# **Town of Hilton Head Island Regular Design Review Board Meeting**

CONSTRUCTION PLANS  
FOR  
**ON-AIRPORT TREE MITIGATION PROJECT**  
**RUNWAY 21 APPROACH**

## DESIGN TEAM/DRB COMMENT SHEET

PROJECT NAME: Airport Tree Mitigation

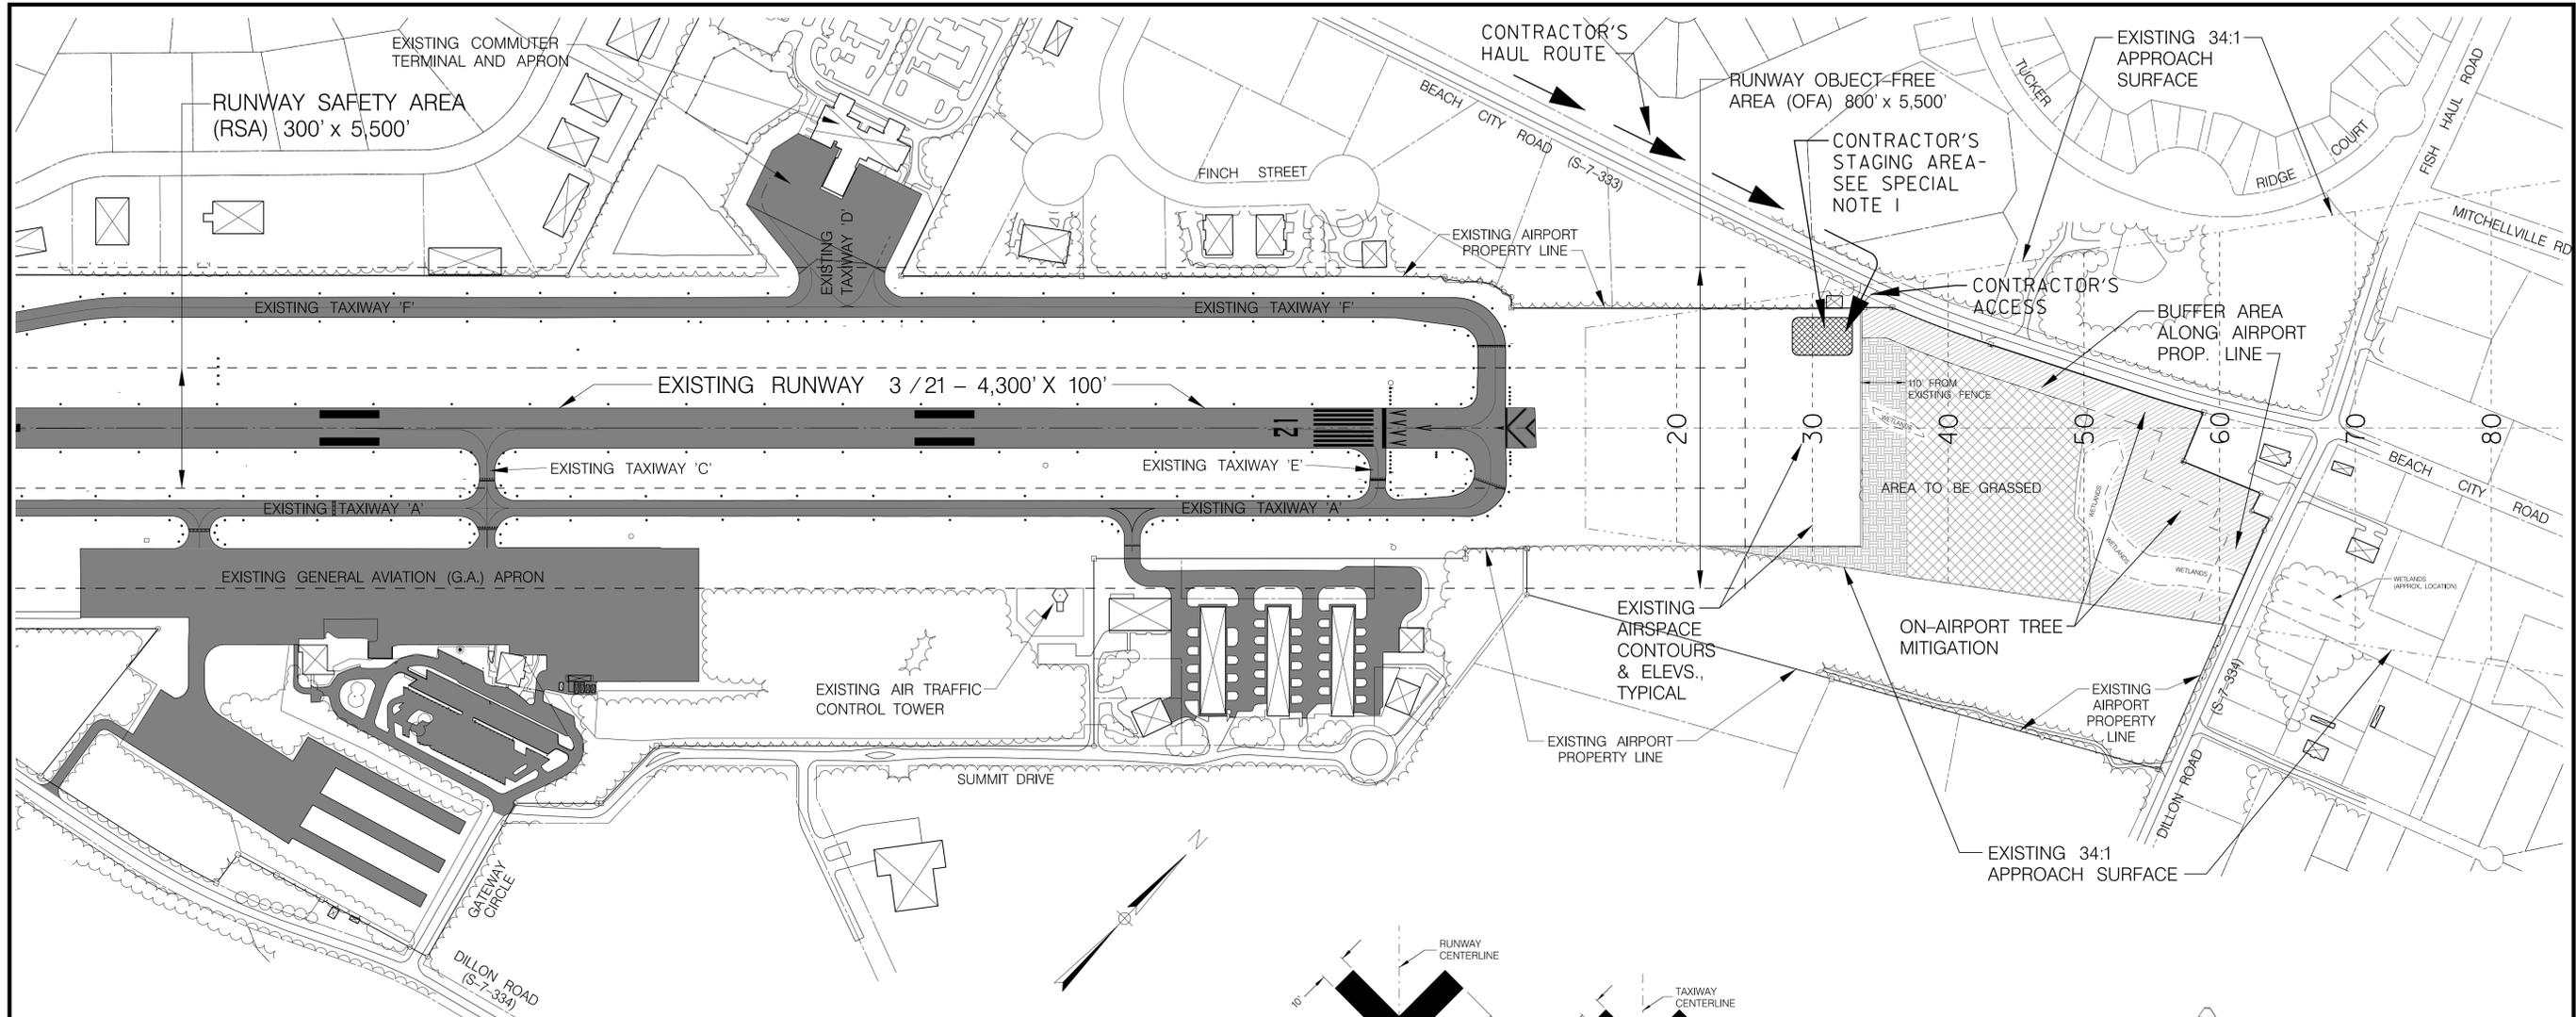
**Comment 01: Maintain plantings for three years**

**Comment 02: Consider installing an irrigation system for watering plants during the three-year maintenance period**

**Comment 03: Address public comment asserting that the buffer parallel to Beach City Road should be 90' wide instead of 75' wide because a 15' wide PSD easement lies within**

**Comment 04: Consider other Category I trees as alternatives to the Little Gem Magnolia if they meet all requirements**

**Comment 05: The LMO stipulates that native grasses are to be planted within the non-buffer area but the plans call for Bermuda to be planted in part of that area**

*Response: The basic construction contract provides for a one-year warranty and maintenance period. An additional two years have been added to the maintenance requirements. Plans have been revised to reflect this change.*

*Response: An irrigation system for 1,300+/- trees would require miles of irrigation line, multiple zones, trenching through root systems and would be very difficult to maintain because of planting density. Therefore we do not recommend installation of an irrigation system. Since the plants chosen are natural to the area and should survive naturally once established it is the intent of the County to cease maintenance after three years when plants will be established. We have added a plant maintenance and watering schedule to the plans and are requiring the contractor to comply with that requirement during the maintenance period. The contractor may water from a truck which can be filled from the airport's water system but must remain outside the buffers.*

*Response: The Town maintains that the 75' width is correct and the Town is requiring that native grasses be planted within the easement, having obtained PSD permission to do so. Revised plans reflect this change.*

*Response: The American Holly will also meet the project requirements and has been added to the planting schedule. 225 American Hollies will be planted thereby reducing the number of Magnolias by that number. Revised plans reflect this change.*

*Response: There is currently a dispute between the LMO stipulation for native grasses and what is acceptable from a safety perspective to the Federal Aviation Administration. Since this is currently unresolved the plans have been revised to reflect alternative grassing materials (Bermuda or Native Grasses) for the portion in question and for the remainder of the non-buffer area. This is being done to establish a guaranteed bid price for each so when the issue is resolved the project can move ahead more expediently.*

TREE PLANTING DETAILS AND NOTES	
FAA A.I.P. 3-45-0030-029-2010	NO. 7 OF 8

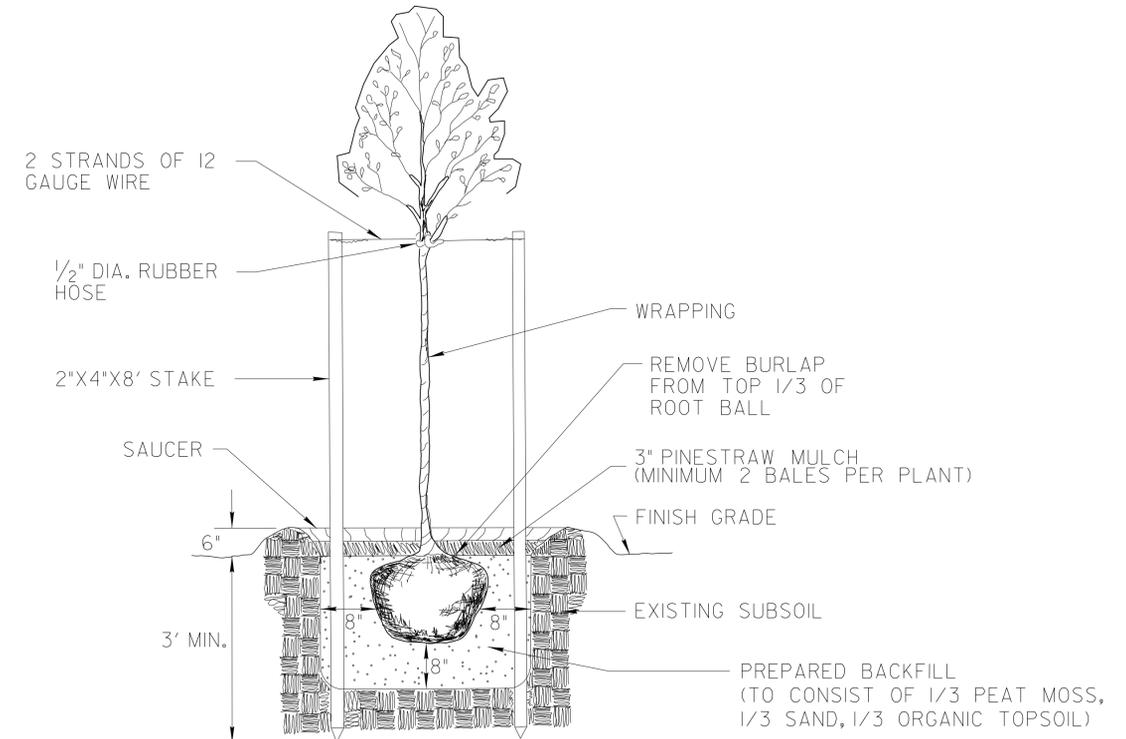
The applicant has met all the directives outlined by the Board in the first review, as outlined in the application materials. Staff would direct the Board's attention to the spacing proposal on the native grasses as 15'-0" on center. Spacing of 30-36" would be more appropriate, depending on the selected species.

ALTERNATE 2 - PLANT AREA WITH NATIVE GRASSES.  
(EQUAL MIXTURE OF SAND CORDGRASS, PINK MUHLY GRASS,  
AND BROOMSEGE. 4" POTS, 15' ON CENTER)

- All plantings to be guaranteed and maintained for one year after Owner Acceptance of Work.
- Maintain plantings for an additional two years after one year warranty period.
